Your ref
BN/113/19/PL

Our ref
PLAN-030819

Proposal: All-weather practice arena to support existing equestrian training yard.
Site: BN/113/19/PL: - Highground Barn, Highground Lane, Barnham, PO22 0BU.

ARUN DISTRICT COUNCIL BN113/19/PL

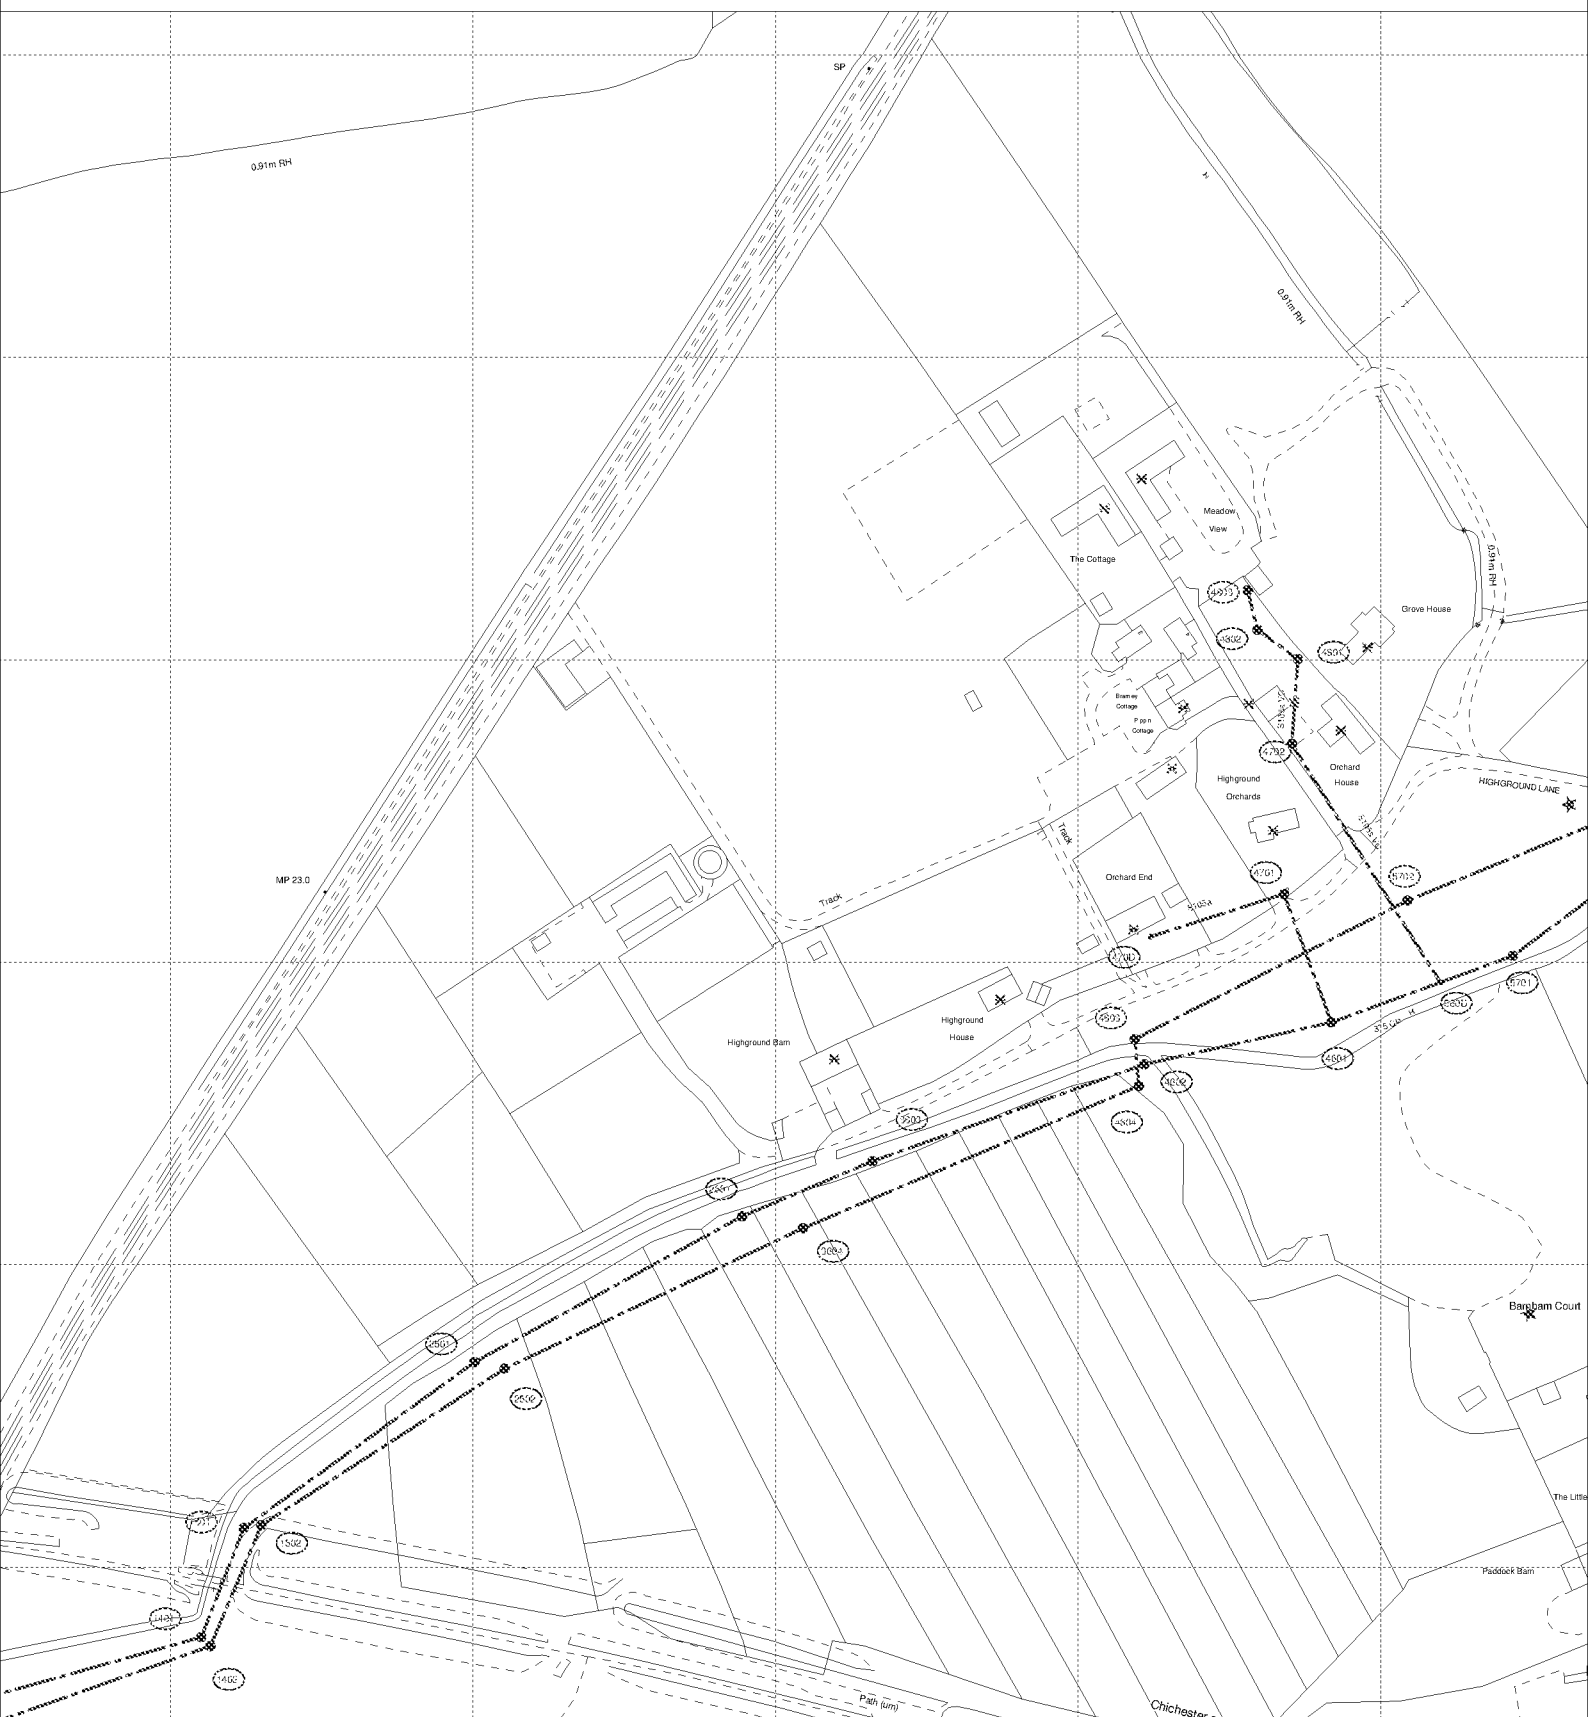
It is possible that a sewer now deemed to be public could be crossing the development site. Therefore, should any sewer be found during construction works, an investigation of the sewer will be required to ascertain its ownership before any further works commence on site.
